Application for Variation of an Environmental Permit

C1. Name of the Current Environmental Permit Holder :
Highways Department
C2. Application No. of the Current Environmental Permit : EP-541/2017
C3. The Current Environmental Permit was Issued in : month / year

**CE72/2015 (HY) Flyover from Kwai Tsing Interchange Upramp to
Kwai Chung Road**

Environmental Review Report

GIN DRINKERS BAY LANDFILL
CONSULTATION ZONE AND
PROPOSED BOUNDARY

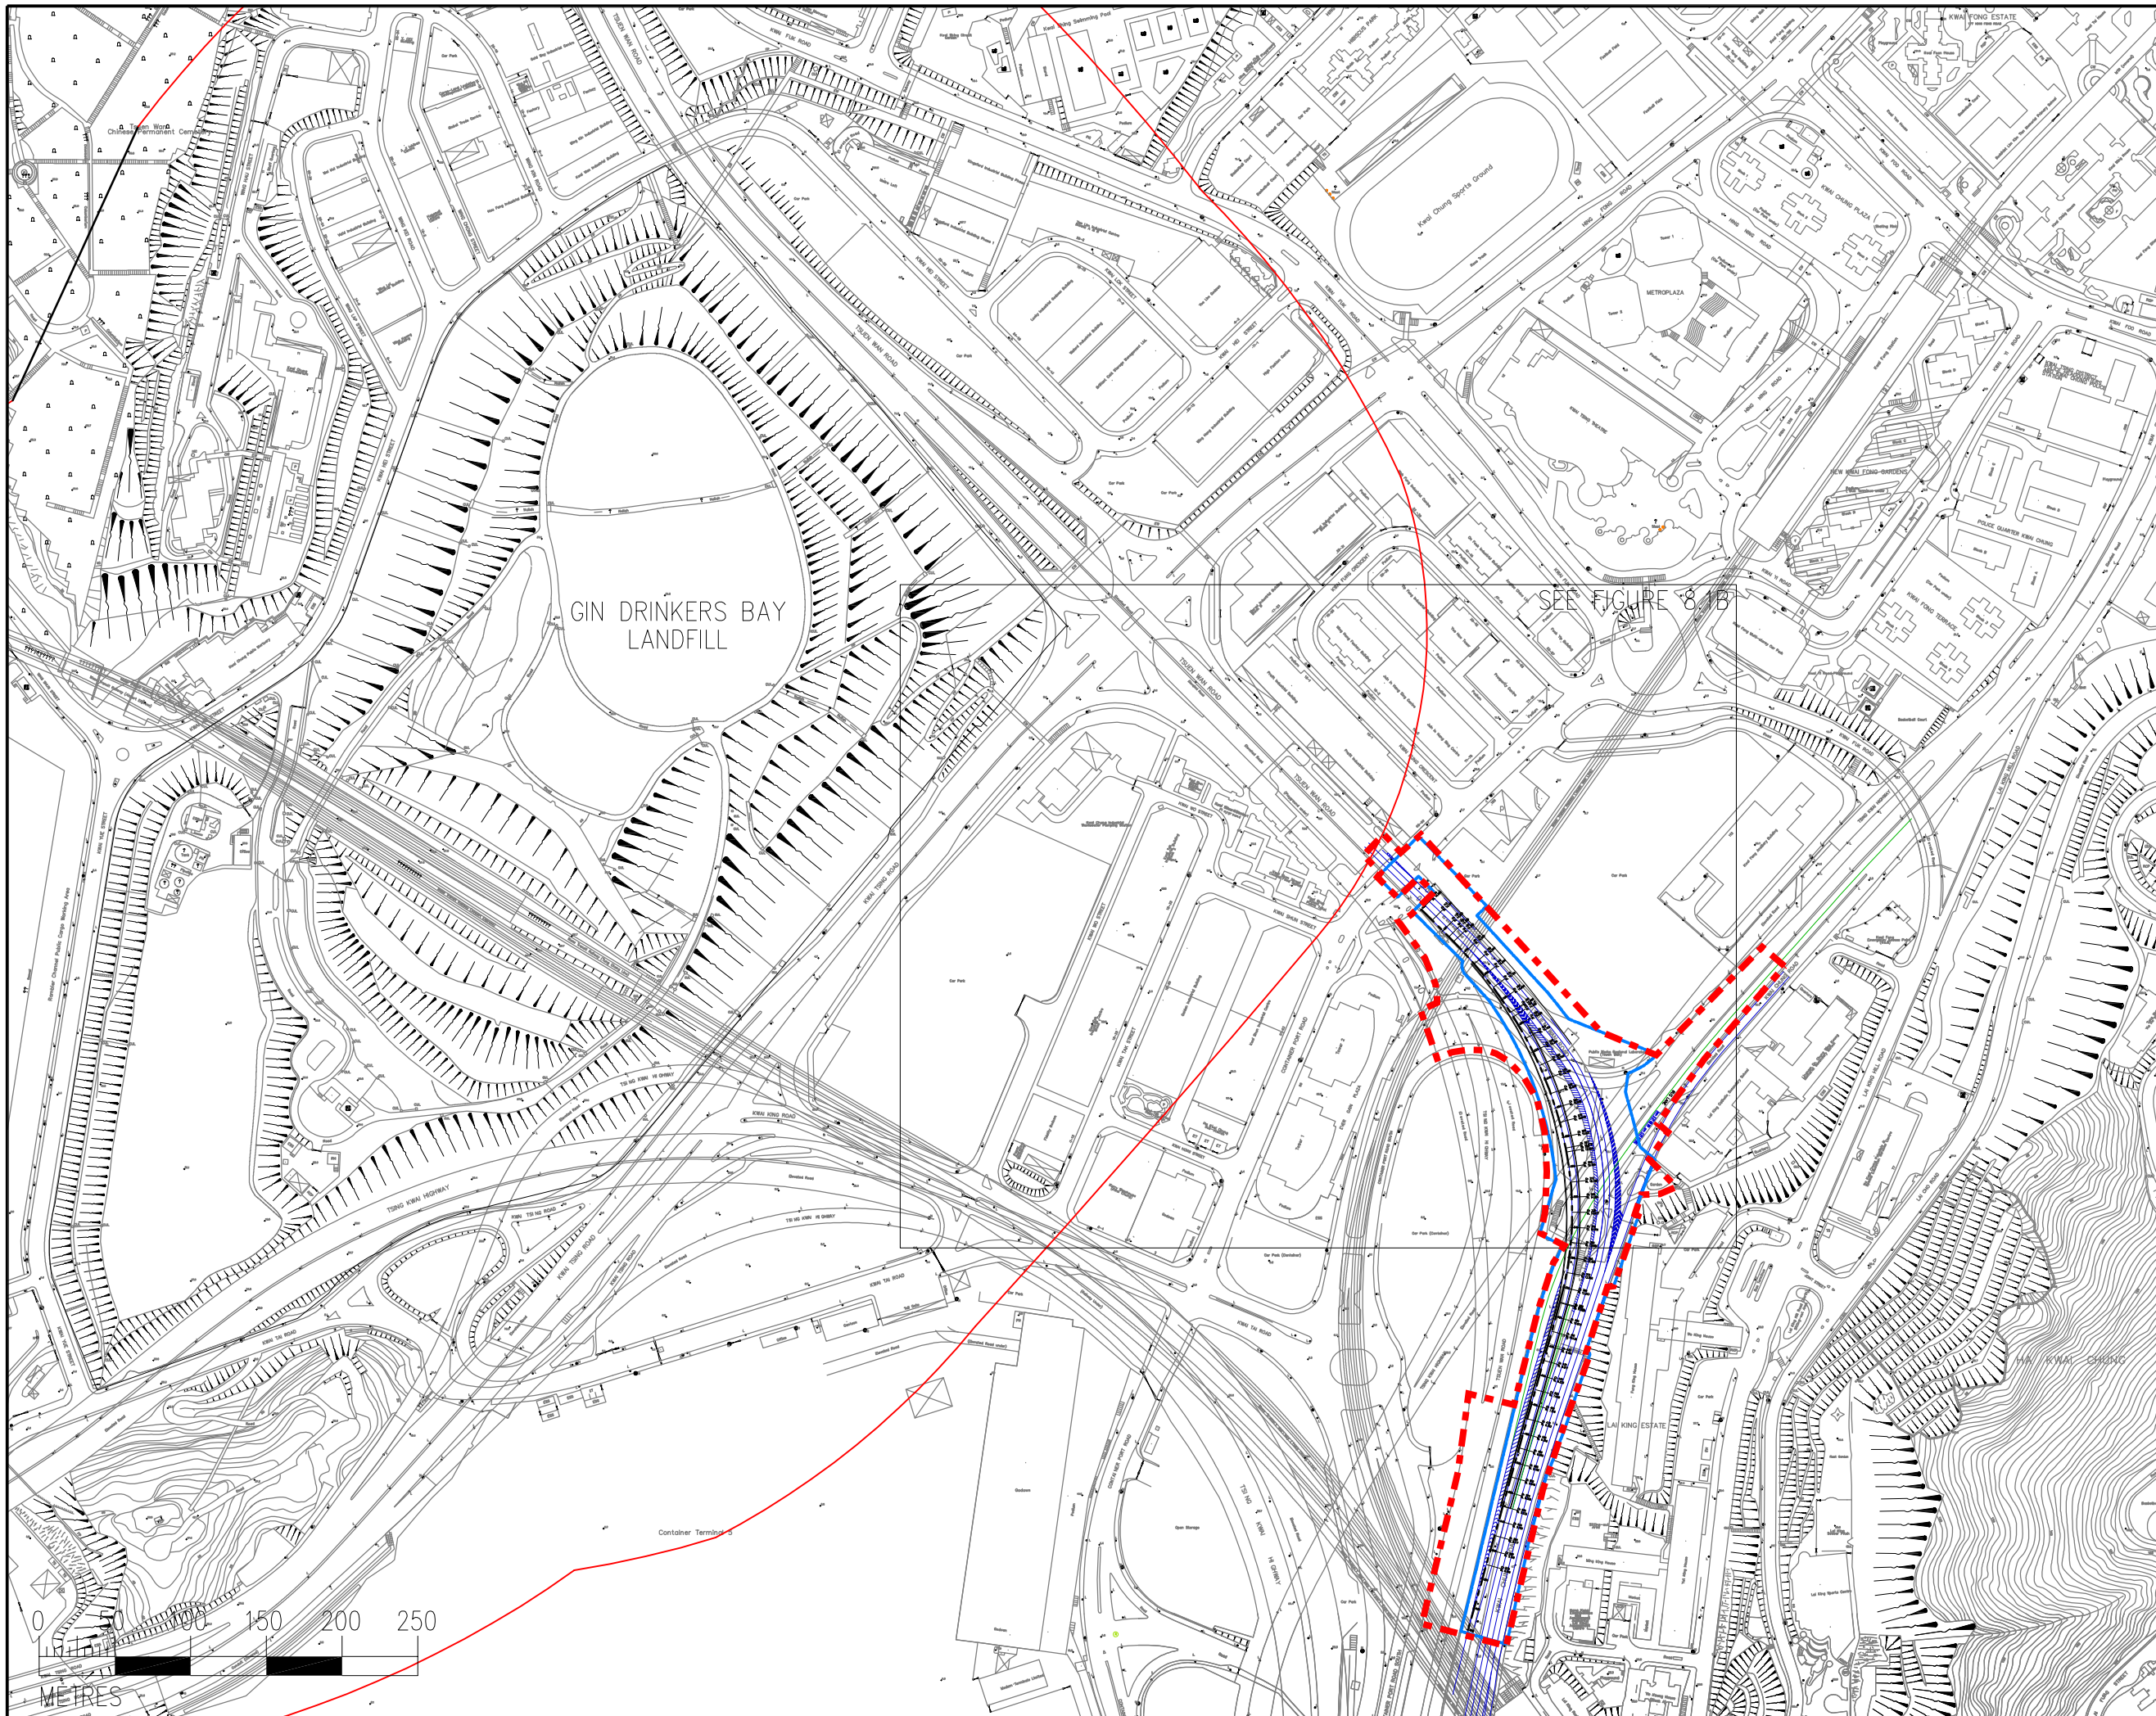
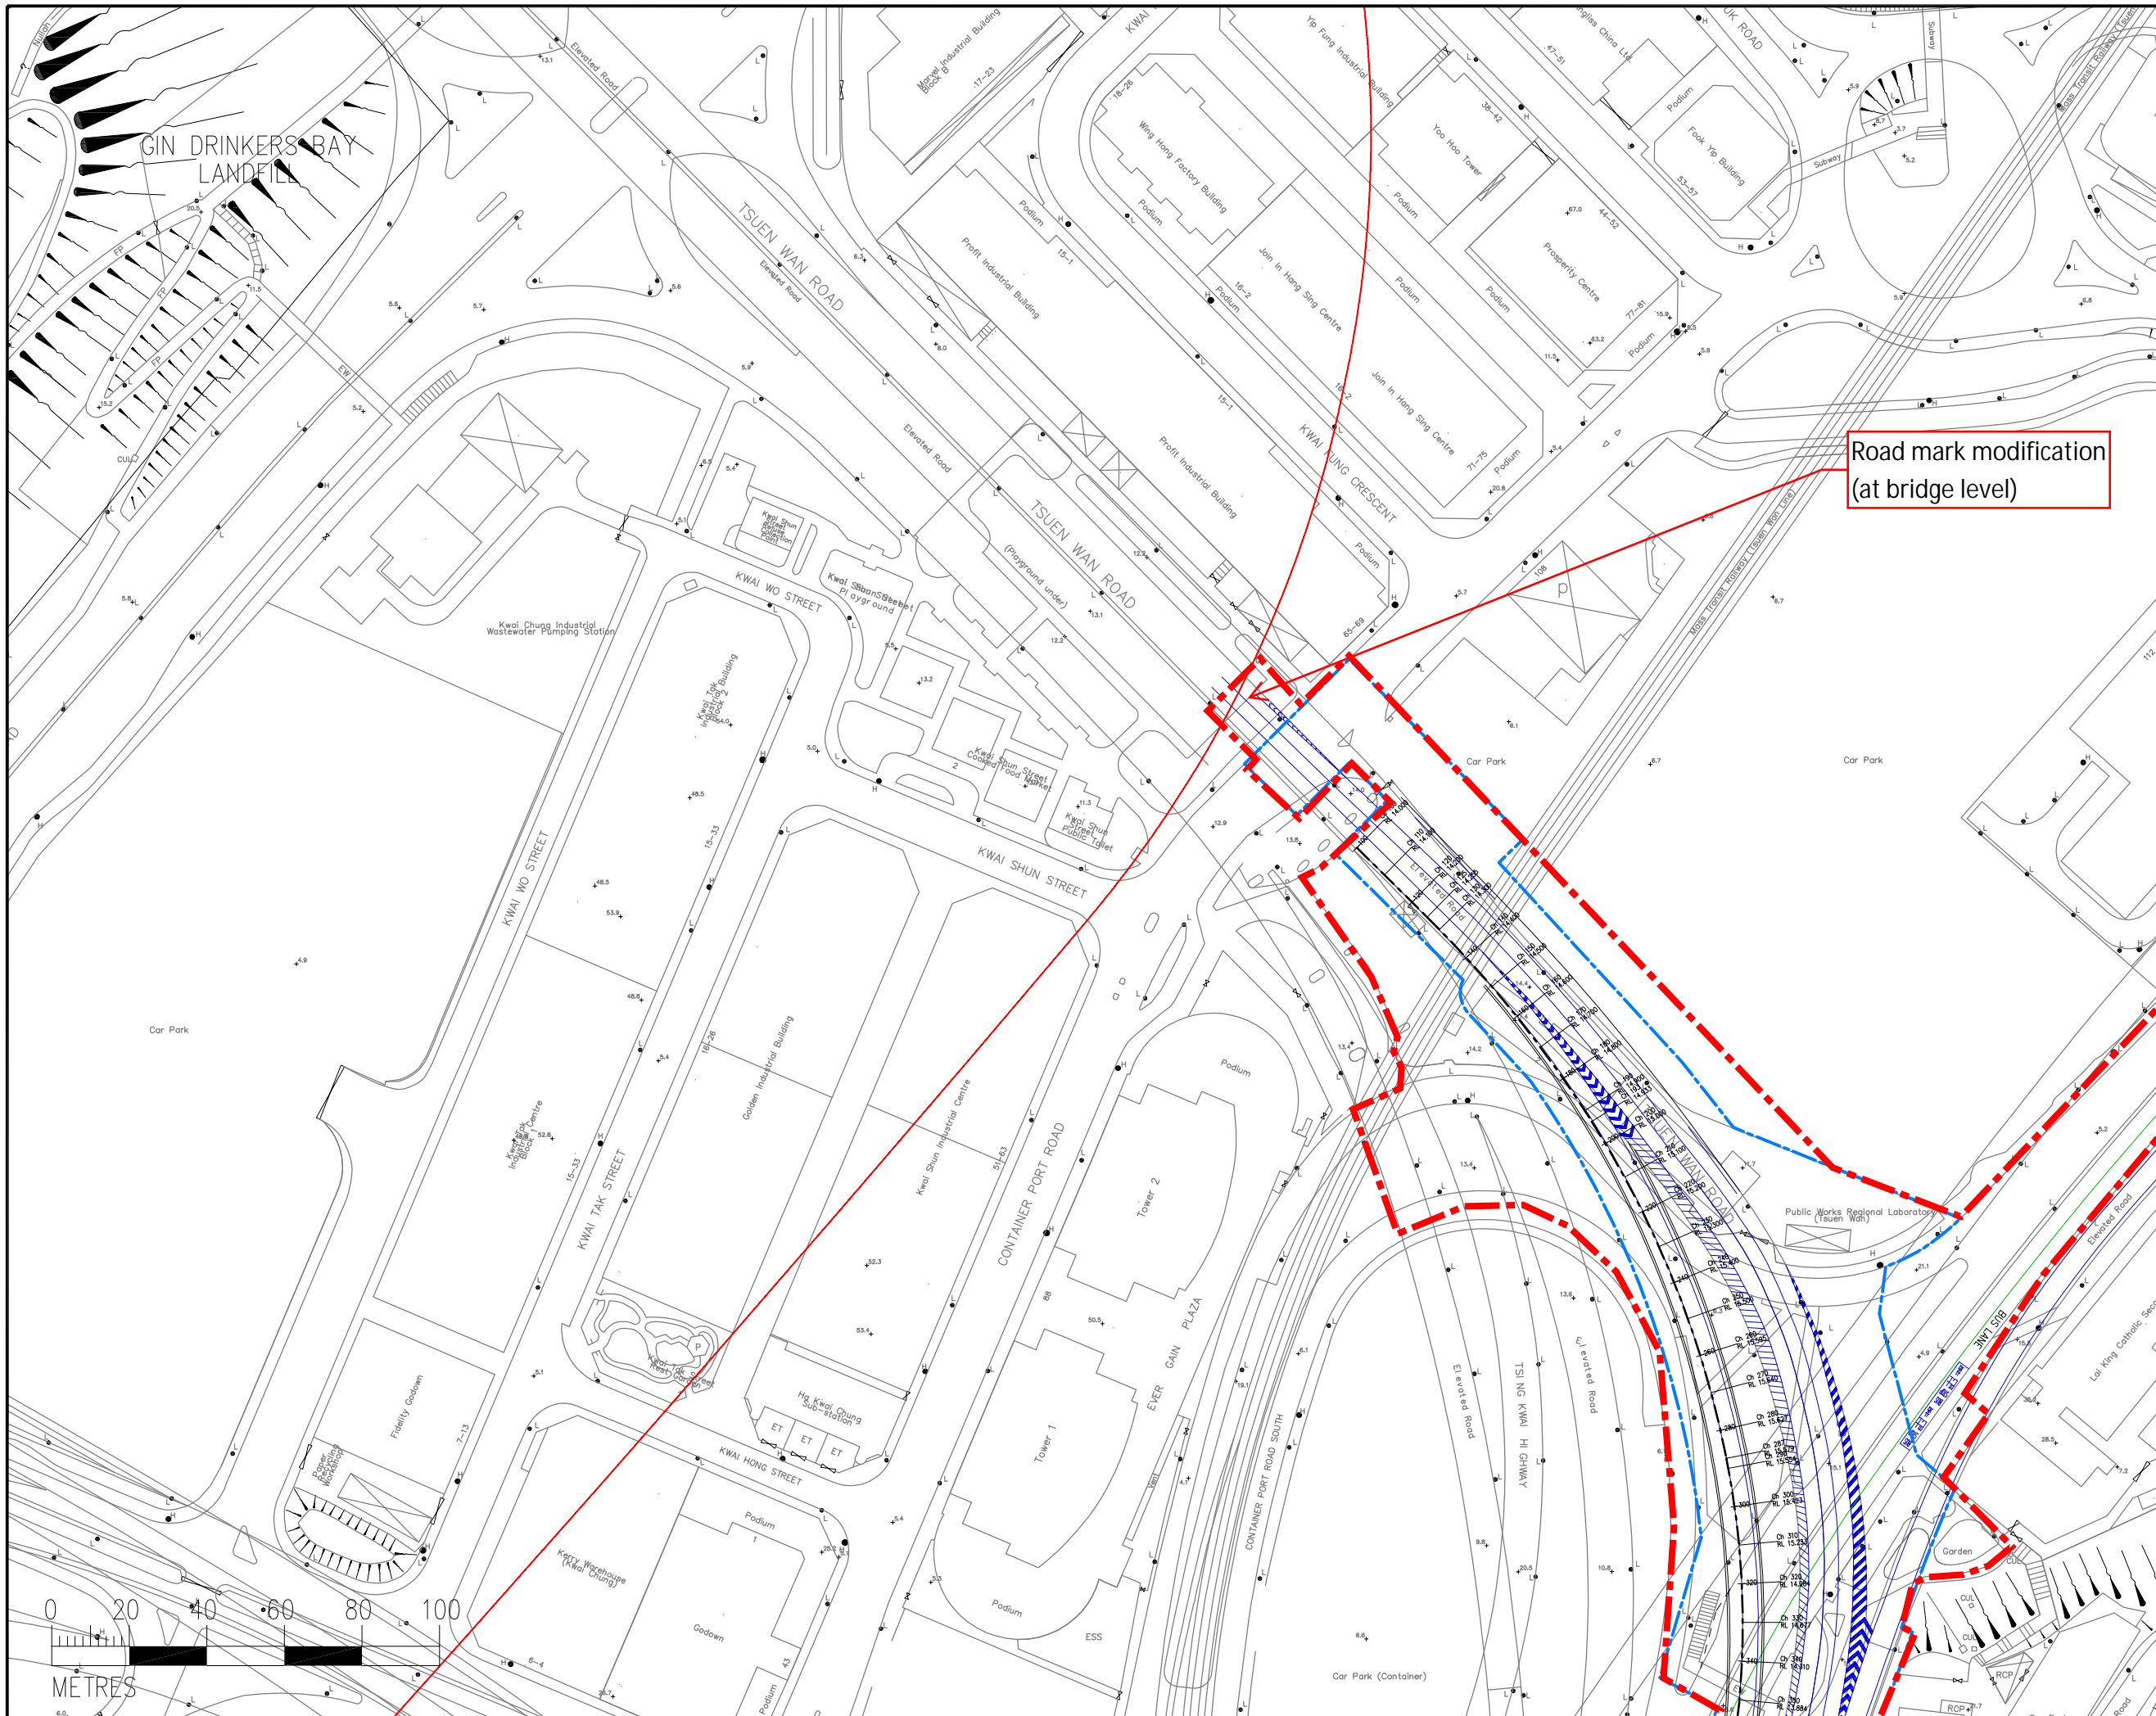
7.3.1 As shown in **Appendix 7.1**, part of the extended area A1 at Tsuen Wan Road falls within the 250m Consultation Zone of the restored Gin Drinkers Bay Landfill. The area located within the Consultation Zone is approximately 40 m². The proposed new works involving road marking modification will be conducted at road surface. There is no ground excavation nor new underground utility connection for the Project within the Landfill Gas Consultation Zone.

7.3.2 Therefore, the LFG hazard assessment is considered not necessary unless there is any possible change(s) on the design in the future that the project/construction boundary shows encroachment on the Consultation Zone and include any ground excavation or new underground utility connection within the landfill gas Consultation Zone.
